Planning Assessment Report

Application to Modify the Minister's Approval for the construction of Auburn Hospital

Major Project 06-0129 MOD 1

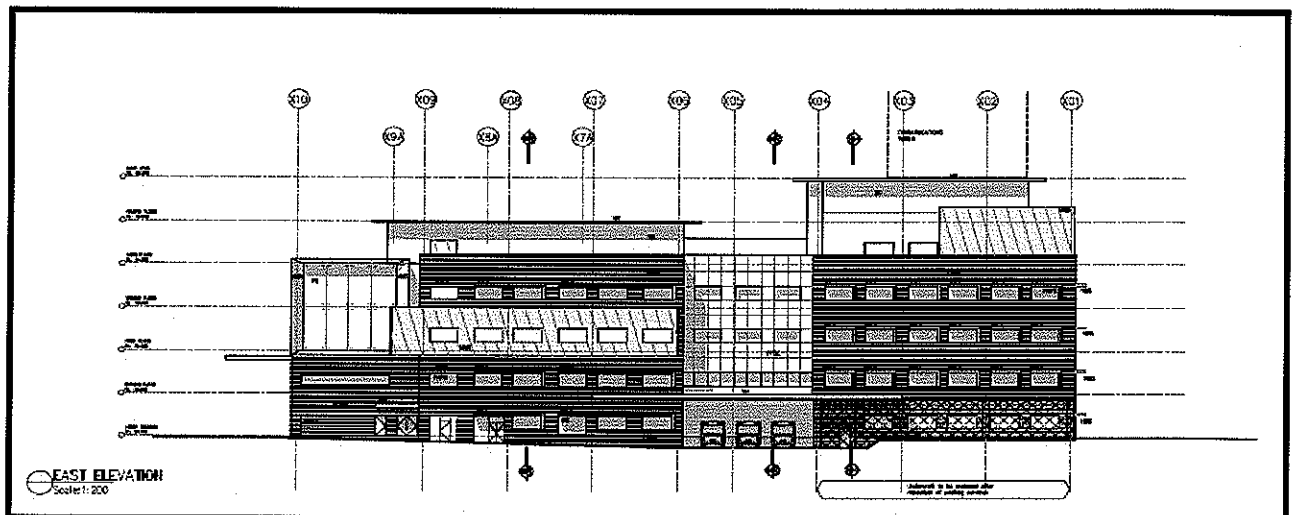
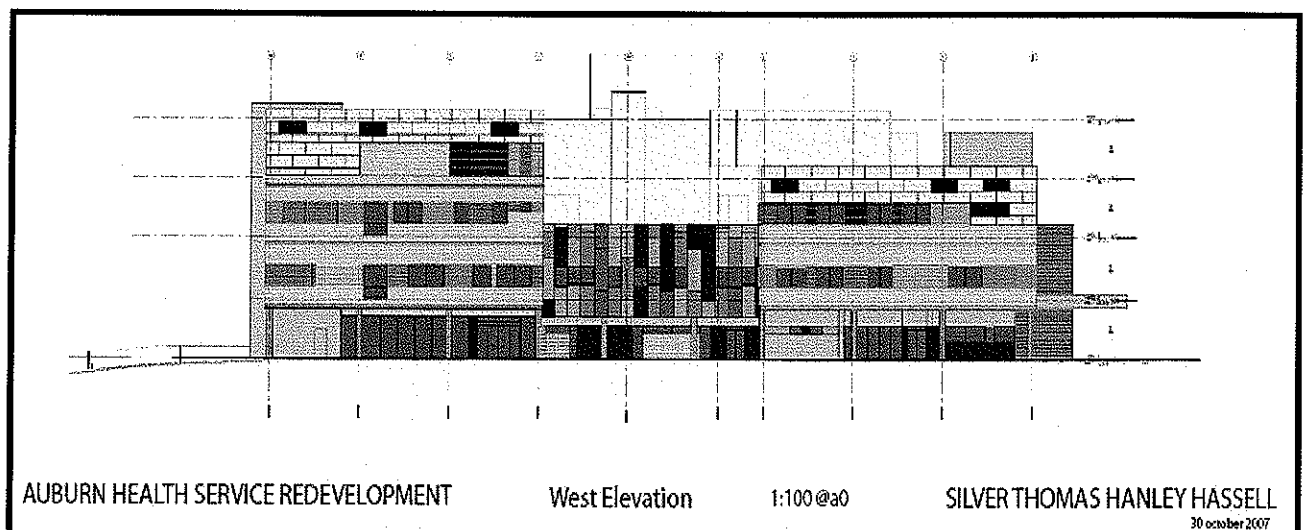
- Redesign of the hospital building including the façade, external treatments and building layout;
- A reduced building height;
- A revised car park layout;
- Increased car parking from 272 to 299 spaces (including the Arthur stone site);
- Construction of a bulk oxygen storage facility;
- Revised entry and exit points; and
- A minor increase in GFA from approximately 23,000sq.m to 24,578sq.m.

The modified building will still provide 184 beds and will still perform the same operations and achieve the same objectives as the original approved proposal. A comparison of the approved facility and the amended facility can be seen below in **Figures 2 and 3**. A computer generated photomontage of the revised design can be seen overleaf.

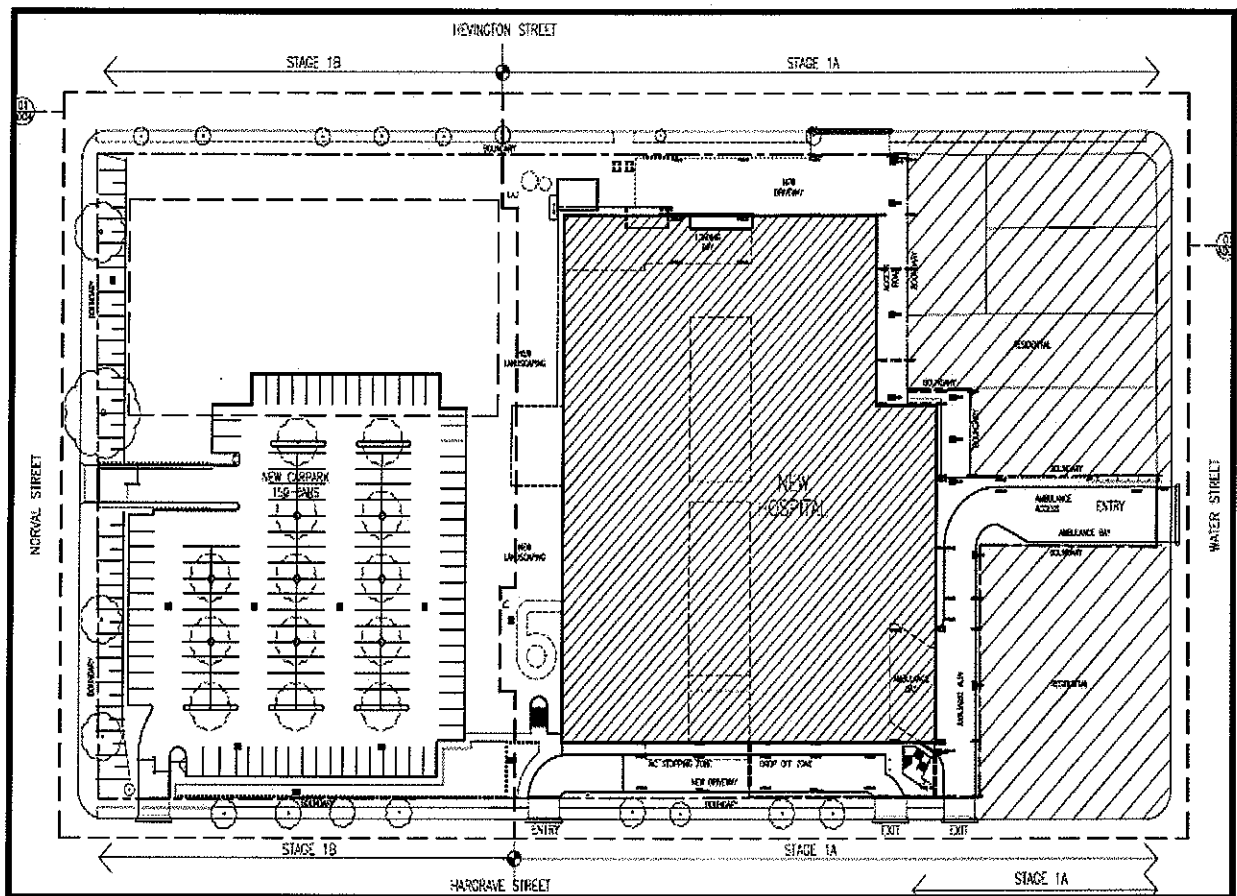
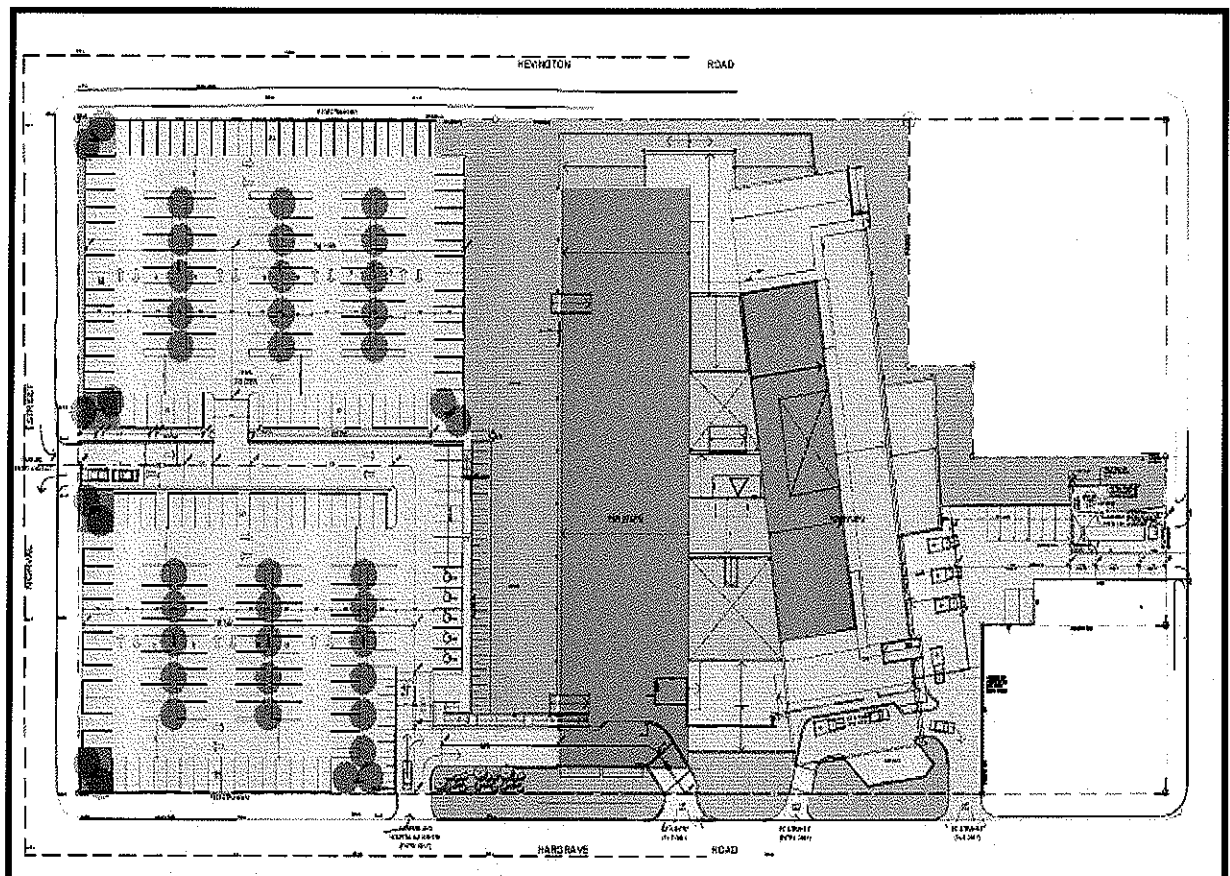
The layout of the approved facility and the modified proposal can be seen in **Figures 4 and 5**.

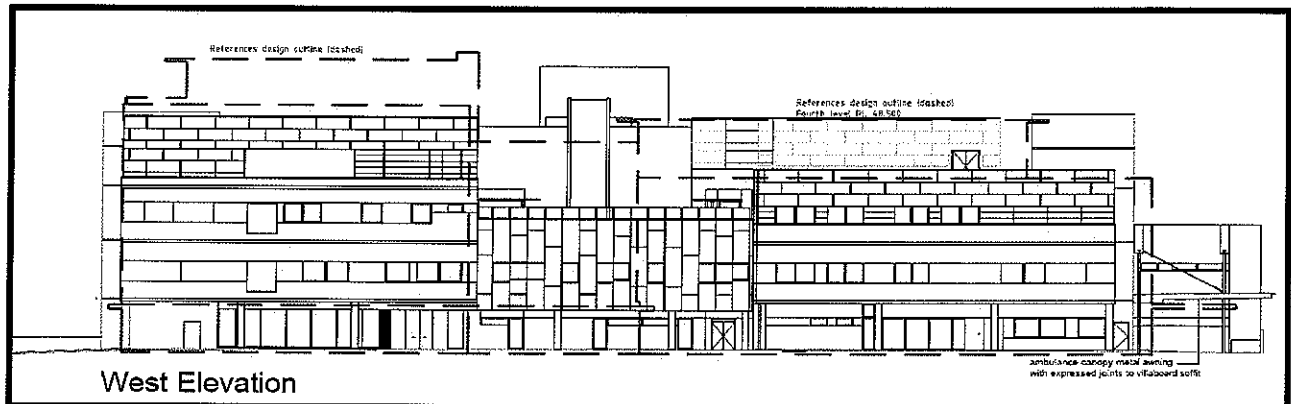
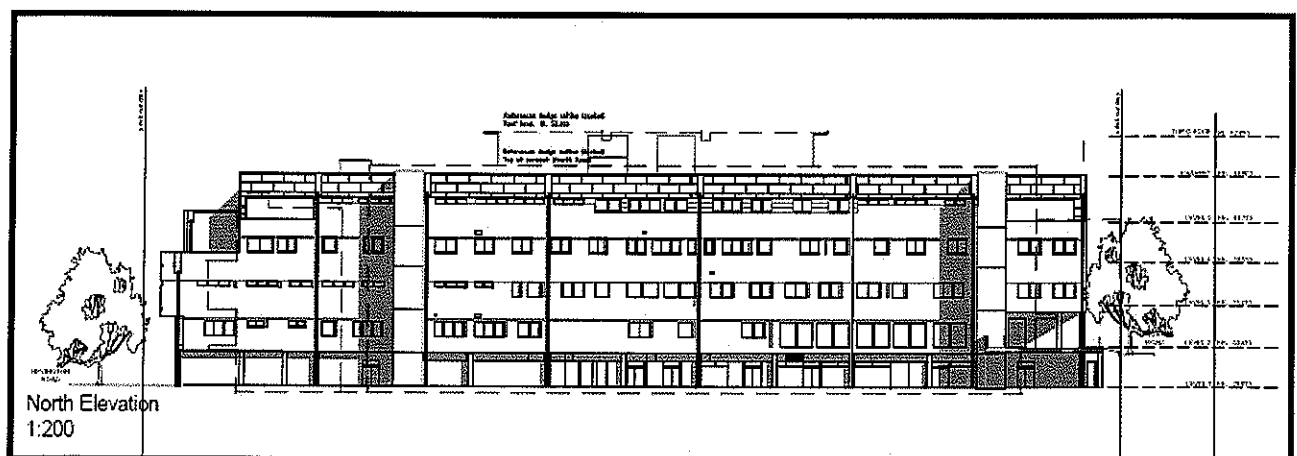
The main aspect of the Modification relates to the redesign of the Auburn Hospital building. The objective of the redesign is to increase the environmental performance and functionality of the facility. A comparison of the approved building against the modified building can be seen in the overlay in **Figure 6** and **7** below. The outline of the approved building is illustrated in red.

As illustrated in Figure 6 and 7 the revised design reduces the height, of the hospital from RL 53.00 at the highest point to RL 48.600 (at the main parapet). This represents 4.4m reduction in height from the original design. The reduced height will improve the visual amenity of the hospital when viewed from the street and create a better visual fit within an area which is dominated by lower scale residential development. The reduced height will also improve solar access to neighbouring properties.

Figure 9 – Revised Loading Dock

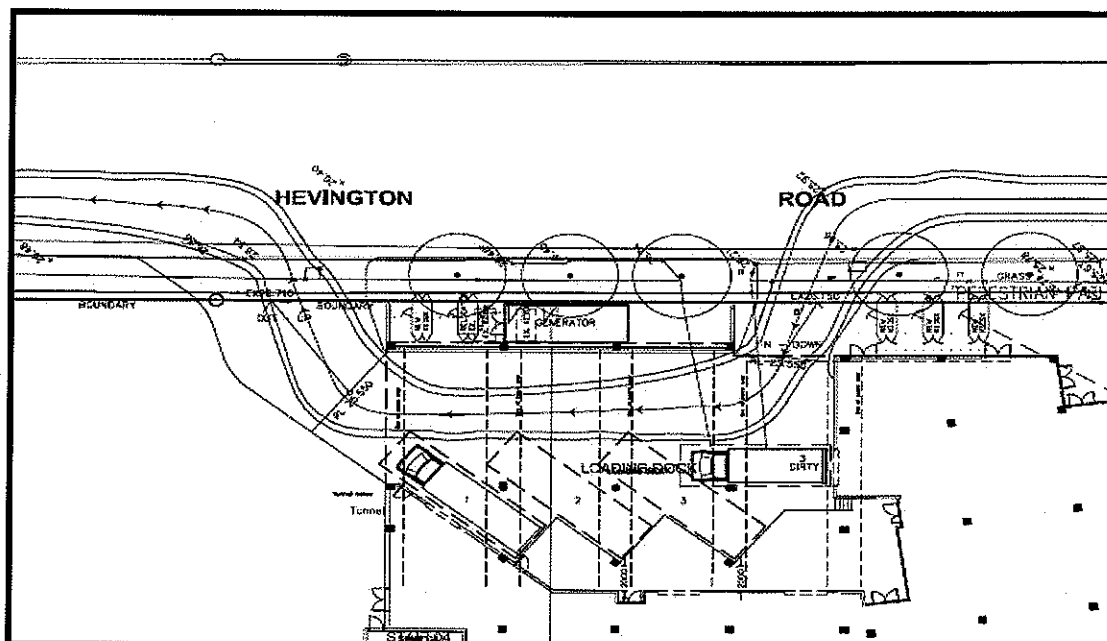
The Hevington Road loading dock has been modified to include a separate entry and exit point. The original loading dock had a shared entry and exit, with limited manoeuvring area on site. The original loading dock also required a section of road (opposite side of Hevington Road) to be marked 'no parking' to ensure that trucks had sufficient manoeuvring area to leave the site. The original loading dock can be seen below in **Figure 8**.

As a result of this modification, condition B10 requiring no parking signs to be erected on the opposite side of Hevington Road will be deleted from the determination.

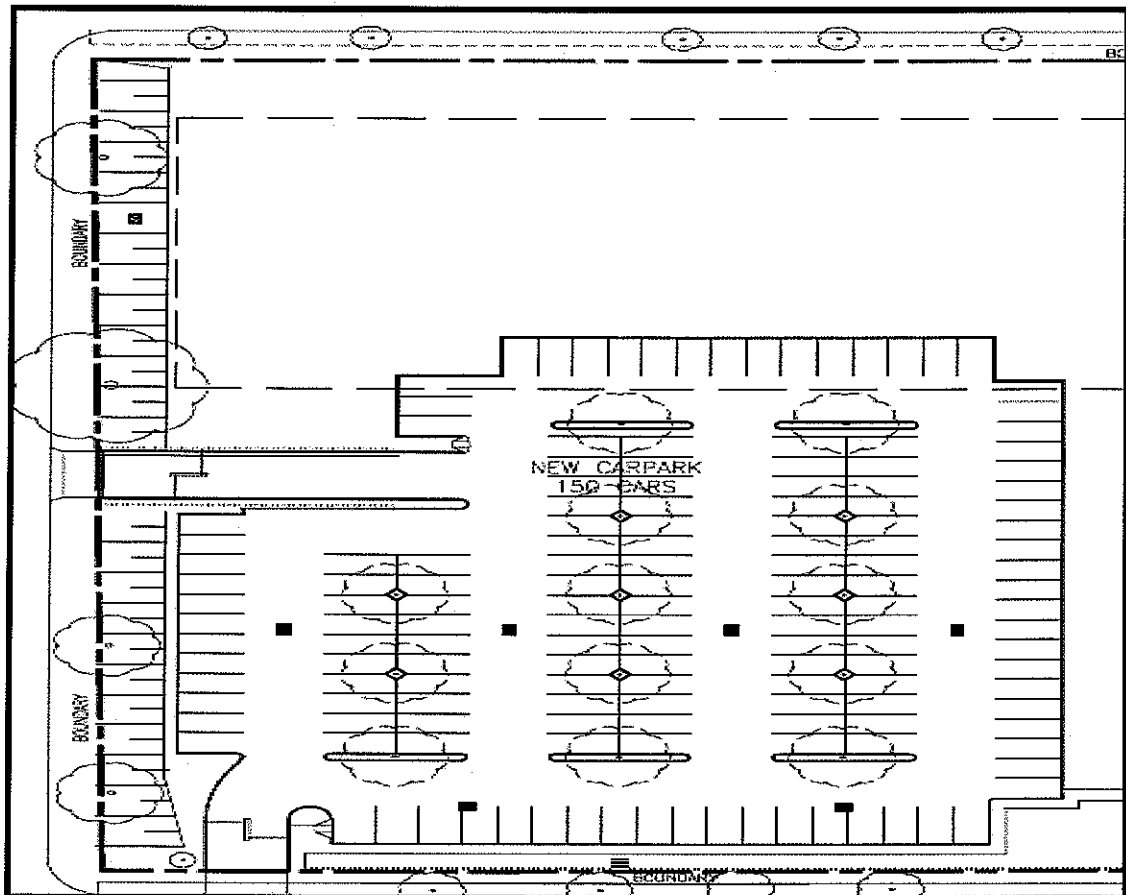
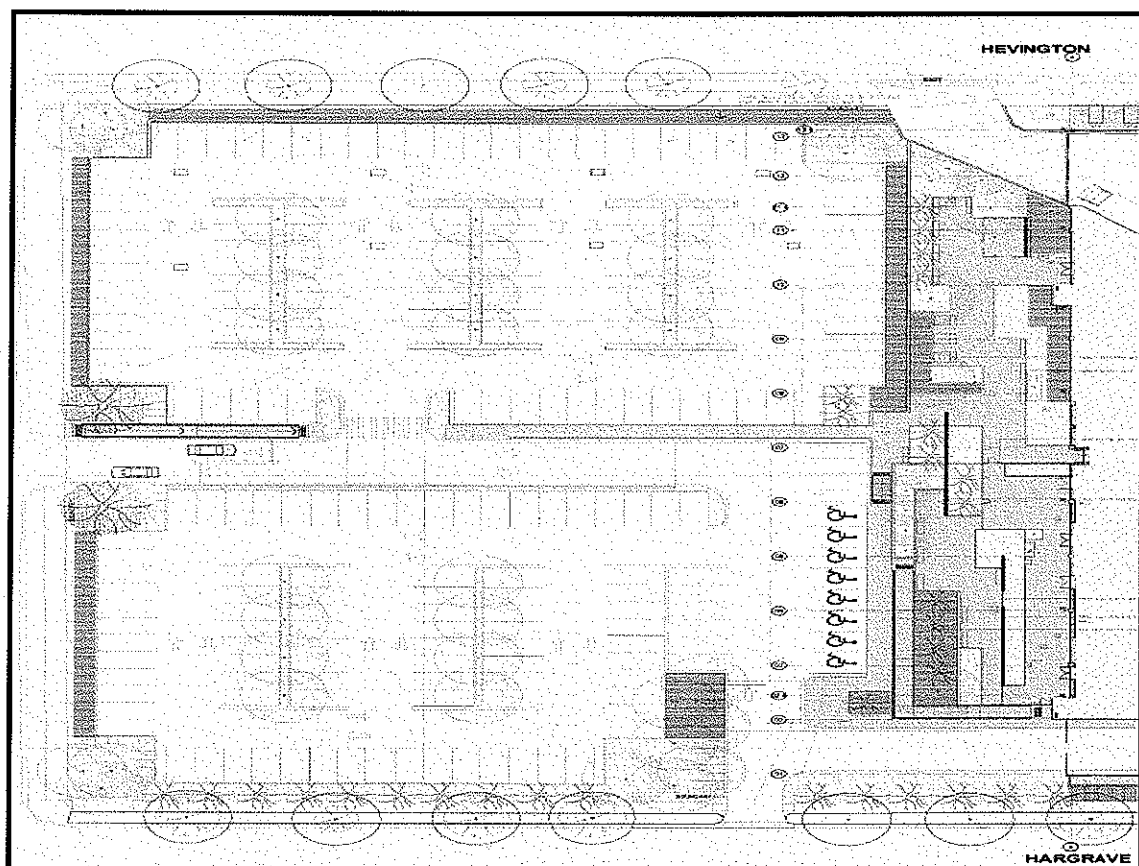
The approved car park provided for 150 onsite car parking spaces on the main hospital site, whilst the modified proposal now seeks approval for 250 onsite car parking spaces. The provision of additional perimeter landscaping surrounding the car park has however resulted in the loss of 17 spaces. The total number of on site car parking spaces now proposed is 233. The old and the new car parking layout is illustrated in **Figure 10** and **11**.

Concern was raised regarding the lack of perimeter landscaping provided around the main car parking area in the revised proposal. As a result, the proponent has introduced a landscaping margin of 2.5m to the East and Western boundaries and a 3m wide landscaping margin to the Northern boundary. Small deciduous trees will be planted within the Western margin while medium to large shrubs set within ground cover will be introduced within the North and Eastern boundaries. Tall Cumberland Plain trees will be planted within the corner elements of the two car parking areas and also within the grounds of the car park. The revised landscaping scheme is illustrated in **Figure 11**.

As a result of this modification condition B12 requiring 273 car parking spaces will be modified to account for the 299 car parking spaces now proposed.

As a result of the additional landscaping details submitted, condition B13 requiring further information regarding the Water Street entrance landscaping will be deleted. It is considered that sufficient landscaping to the Water Street entrance has been provided under the modified landscaping plan. This condition will however be replaced with condition B11 requiring further details of the species to be planted in the perimeter landscaping surrounding the main car park.
